## PLAT COMMITTEE

<b>Case Number:</b>	2023-PLT-065 (Amended)
<b>Property Address:</b>	7320 East Hanna Avenue (Approximate Address)
<b>Location:</b>	Franklin Township, Council District #18
<b>Petitioner:</b>	M/I Homes of Indiana, LP, by Brett Huff
<b>Zoning:</b>	D-3
<b>Request:</b>	Approval of a Subdivision Plat, to be known as Grayson, Section 1, dividing 19.34 acres into 41 lots.
<b>Waiver Requested:</b>	None
<b>Current Land Use:</b>	Undeveloped
<b>Staff Reviewer:</b>	Allison Richardson, Senior Planner

# GRAYSON - SECTION 1

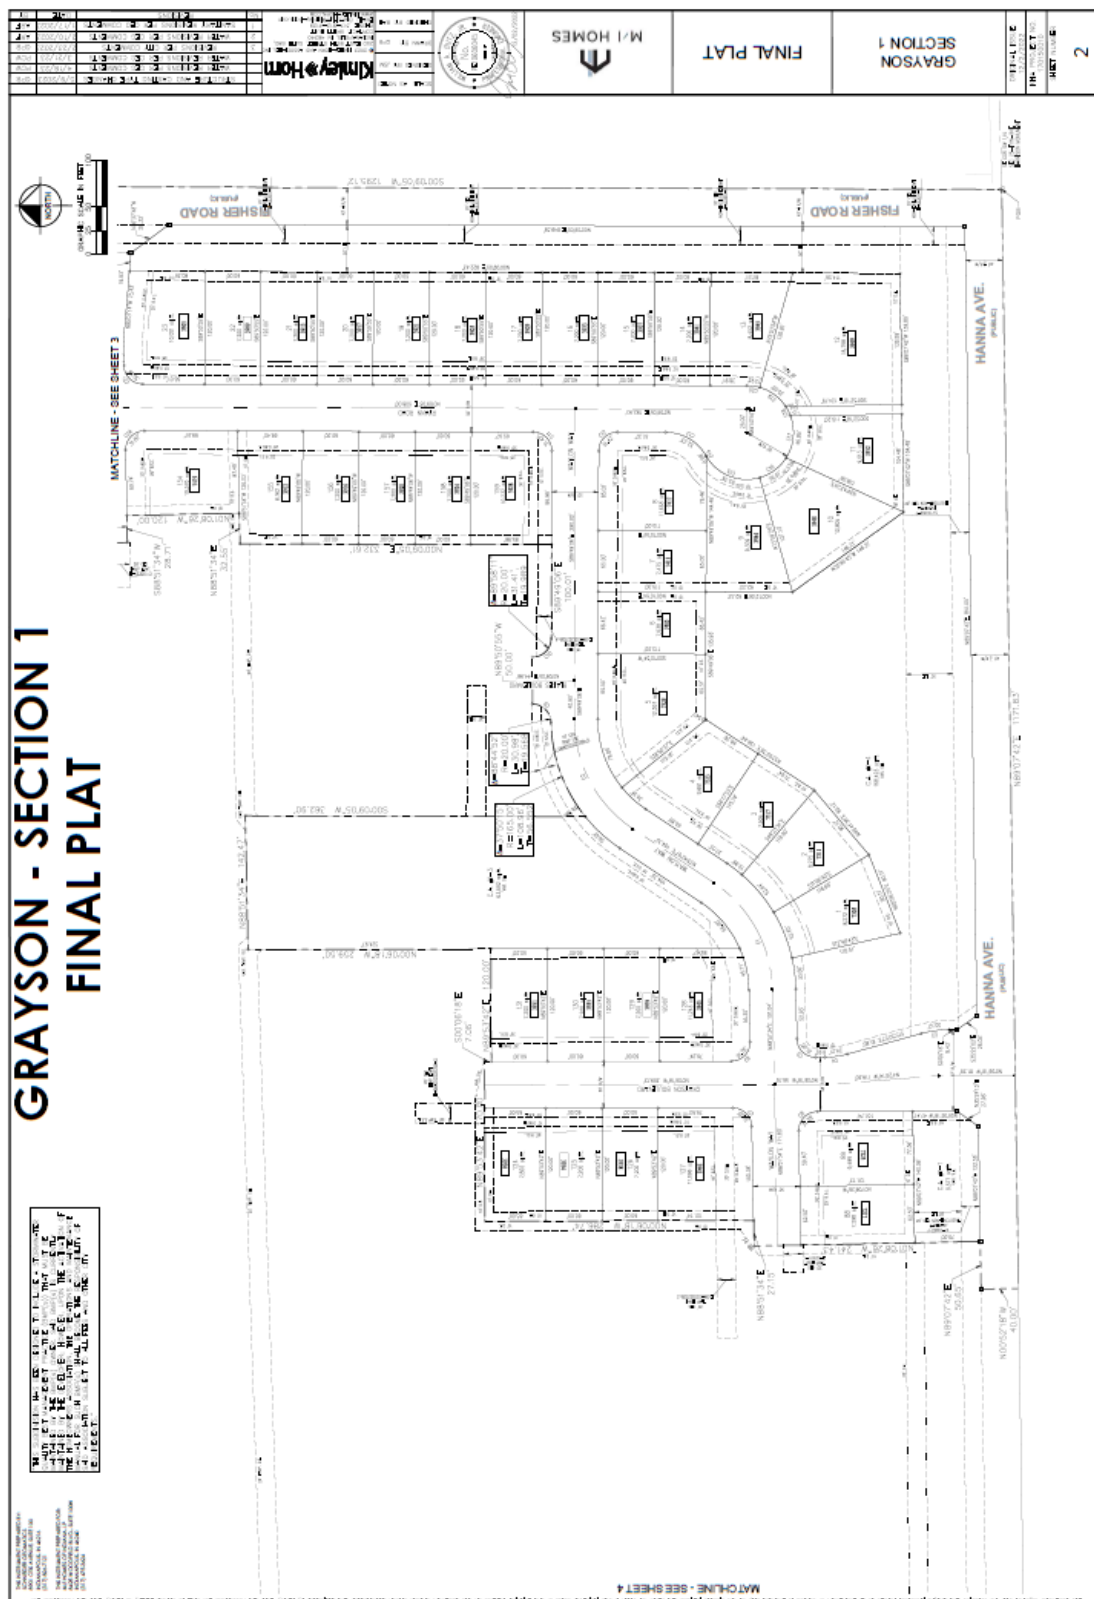
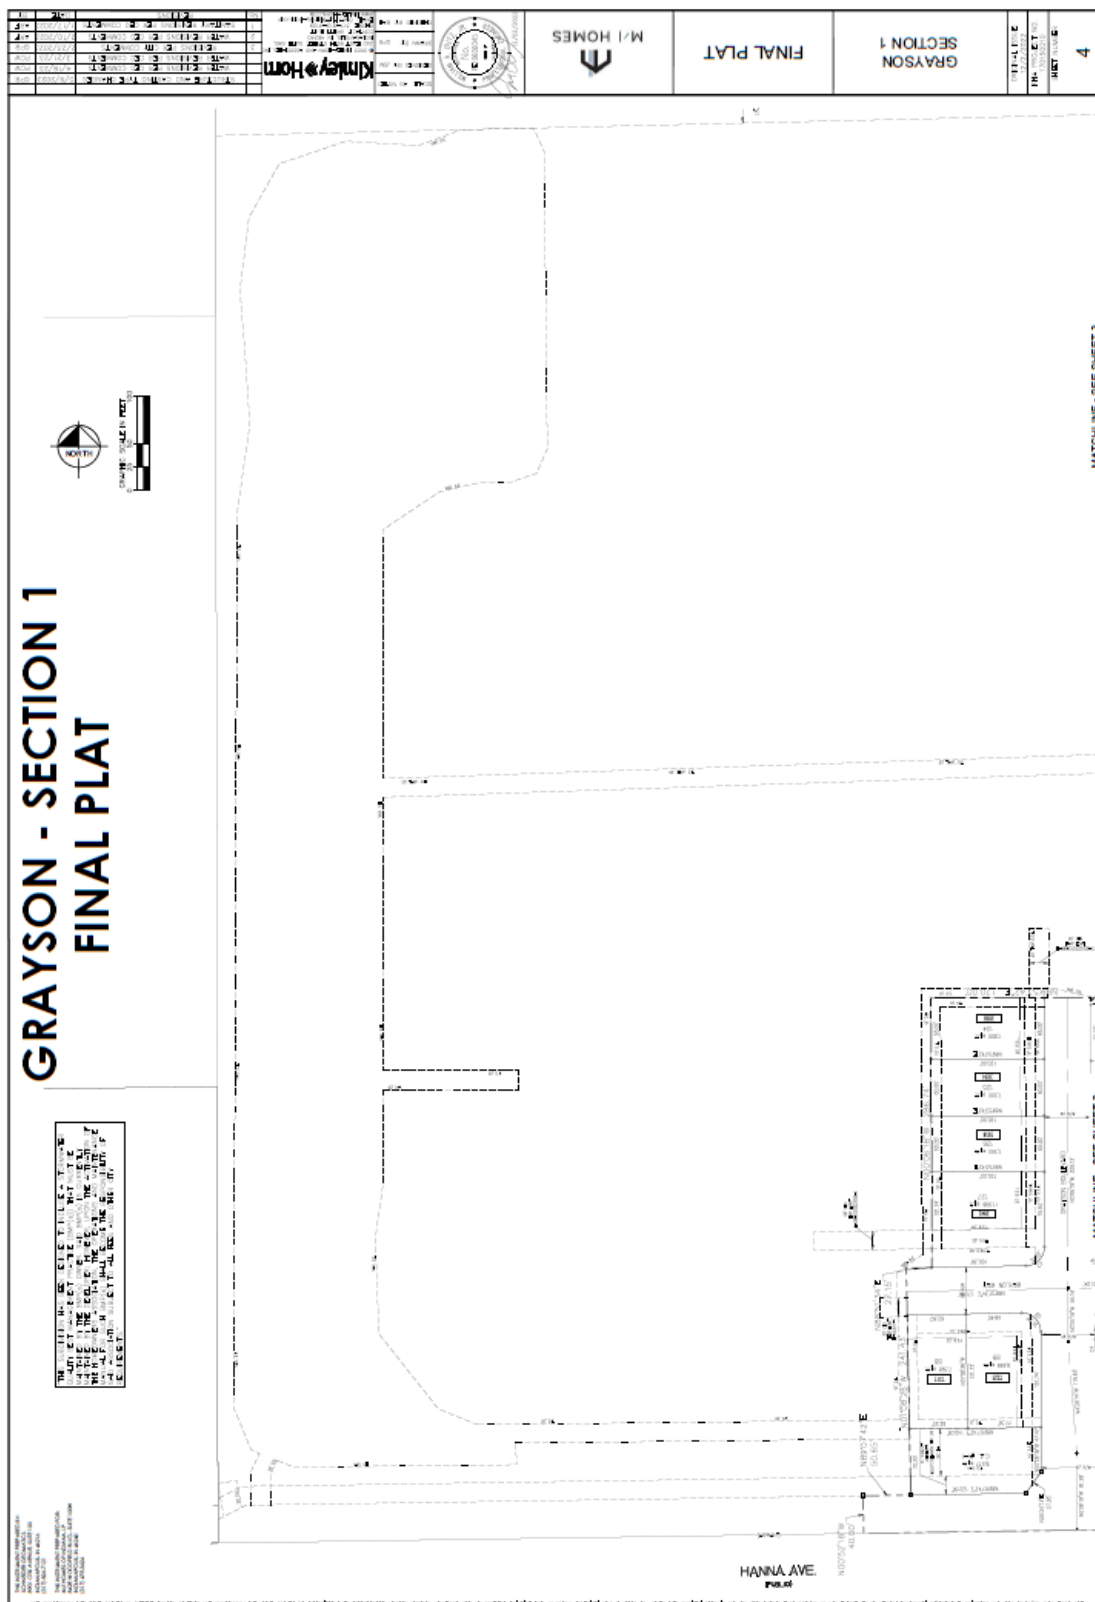
Staff recommends that the Plat Committee **approve** and find that the plat, file-dated August 2, 2023, complies with the standards of the Subdivision regulations, subject to the following conditions:

1. That the applicant provides a bond, as required by Section 741-210, of the Consolidated Zoning and Subdivision Ordinance.
2. Subject to the Standards and Specifications of Citizens Energy Group, Sanitation Section.

3. Subject to the Standards and Specifications of the Department of Public Works, Drainage Section.
4. Subject to the Standards and Specifications of the Department of Public Works, Transportation Section.

5. That addresses and street names, as approved by the Department of Metropolitan Development, be affixed to the final plat prior to recording.
6. That the Enforcement Covenant (Section 741-701, of the Consolidated Zoning and Subdivision Ordinance) be affixed to the final plat prior to recording

7. That the Site Distance Covenant (Section 741-702, of the Consolidated Zoning and Subdivision Ordinance) be affixed to the final plat prior to recording.

8. That the Sanitary Sewer Covenant (Section 741-704, of the Consolidated Zoning and Subdivision Ordinance) be affixed to the final plat prior to recording.

9. That the Storm Drainage Covenant (Section 741-703, of the Consolidated Zoning and Subdivision Ordinance) be affixed to the final plat prior to recording.
10. That the plat restrictions and covenants, done in accordance with the rezoning commitments, be submitted prior to recording the final plat.
11. That all the standards related to secondary plat approval listed in Sections 741-207 and 741-208 of the Consolidated Zoning and Subdivision Ordinance be met prior to recording the final plat.
12. That a lighting plan compliant with Section 744-600 of the Consolidated Zoning and Subdivision Ordinance be submitted prior to recording the final plat.
13. That concrete sidewalk be installed along the entire frontage on Hanna Avenue and Fisher Road in compliance with Section 744-302 of the Consolidated Zoning and Subdivision Ordinance.
